Minutes – Executive Policy Committee – April 18, 2023

Item No. 9 Subdivision and Rezoning – 963 Centennial Street
(River Heights-Fort Garry Ward)
File DASZ 34/2022 [c/r DAV 151948/2022D]

Title: DASZ 34/2022 – 963 Centennial Street

Issue: For consideration at the public hearing for a rezoning to "RMF-S" Residential Multi-Family Small to permit a townhouse development (seven units).

SITE / ROOF PLAN
Not to scale

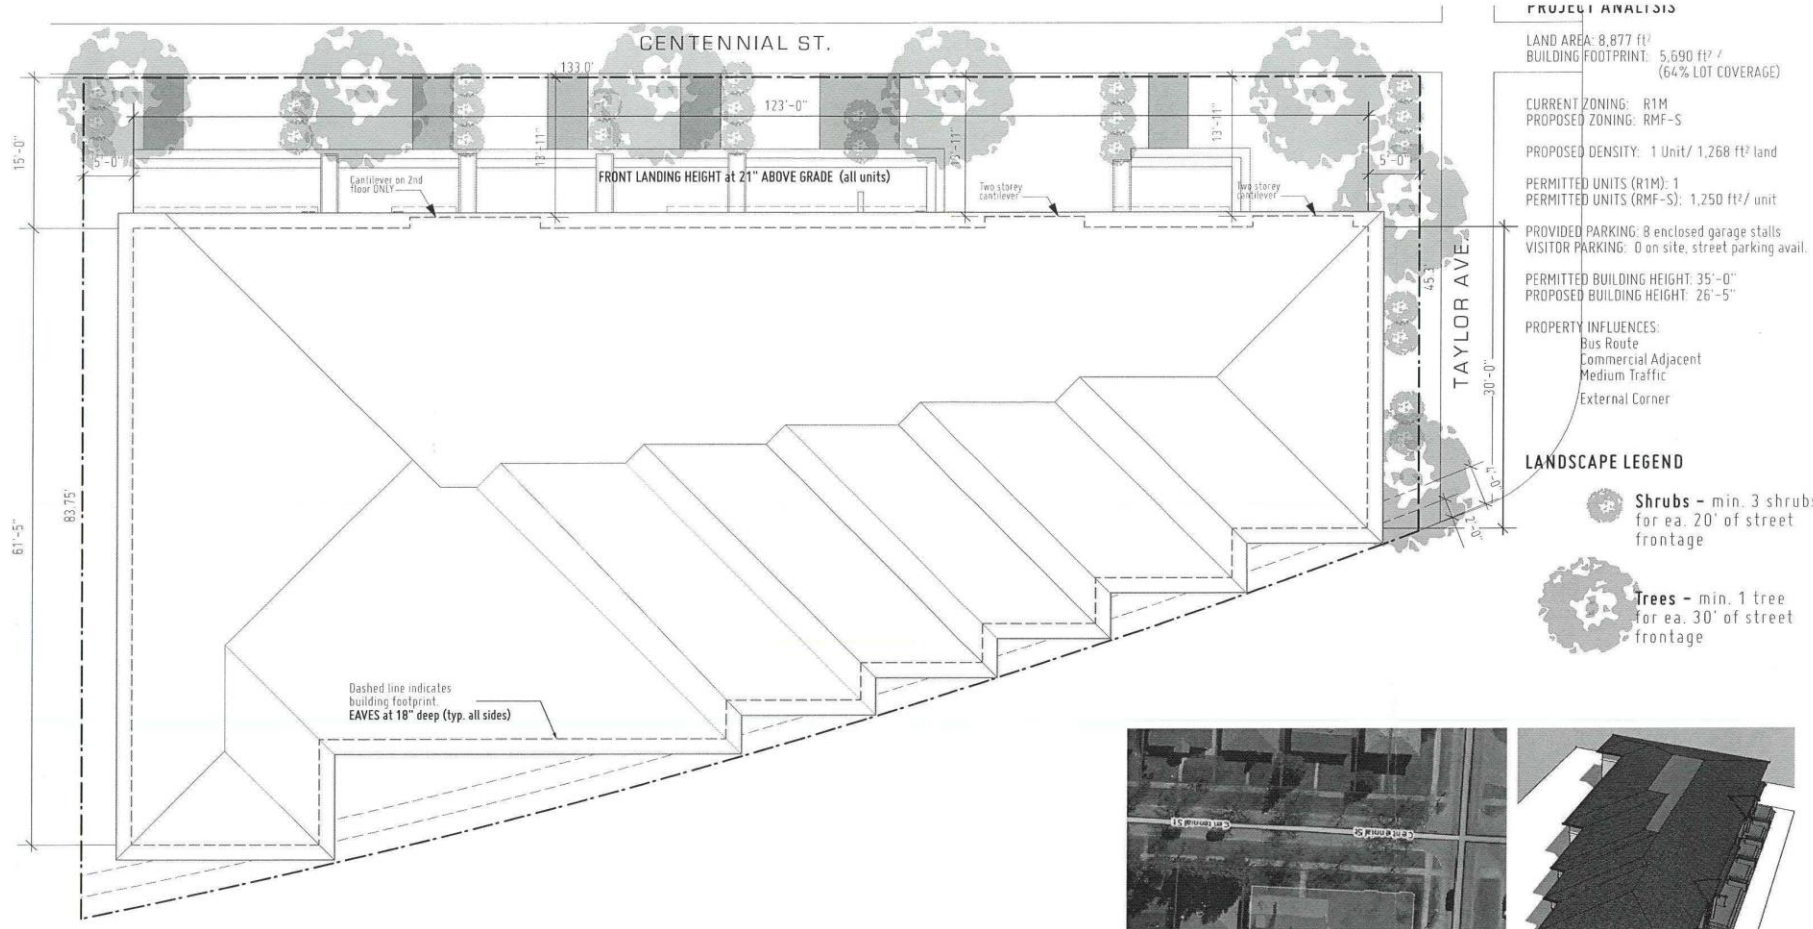
Given the lot dimensions, which become increasingly narrow towards Taylor Ave (45 feet deep), it would appear that the proposed seven-unit townhouse style development could not be accommodated on the subject site while meeting the *Infill Guidelines* and would require substantial front and/or rear yard variances. The document states: “The City of Winnipeg expects that those who develop properties within our Mature Communities will use a suitable building type and design to ensure the new development fits well and responds appropriately to the particular conditions of that site and its surrounding neighbourhood.”

- Lot coverage: 42% permitted, 64% proposed
- Rear yard: Minimum 25 feet required, 2 feet proposed
- Front yard: 25 feet based on front yard alignment (variances permitted within 5 feet of alignment), 15 feet proposed (variance of 10 feet).

- Side yards: Minimum required side yards are 6 feet on each side, 5 feet are provided on each side.
- Corner façade condition: Required window coverage on elevation flanking Taylor Avenue is 15%, 7.2% is proposed. A unit facing the corner street is strongly encouraged.

- One-storey projections into front yard: For a stoop or porch may extend into the required front yard setback 5 feet, but not less than 10 feet from the property line. It appears they are 6-7 feet from the property line. Dimension not shown.

- Soft landscaping: Percentage of coverage is unknown. 20% is required.
- Trees: Required to be planted not less than 6.56 feet (2.0 metres) from a public sidewalk, a minimum of 3.28 feet (1.0 metres) from a property line, and should be located at a sufficient distance from the dwelling to allow for full canopy and root system development. The proposed trees appear to be shown less than 5 feet from sidewalks on Centennial Street and Taylor Avenue.

- The subject property is a large property with an irregular shape. Given the lot is approximately 45 feet deep at its smallest depth, it's unlikely that a townhouse development could fit on the property without substantial front and rear yard variances. Support for a rezoning would be dependent on high-quality, context sensitive plans that are consistent with the *Infill Guidelines*.

- The proposed subdivision/rezoning application is not considered compatible with the surrounding area given it is unable to meet design guidelines such as front, rear, side yards and lot coverage, as well as glazing requirements, which minimize concerns related to massing.
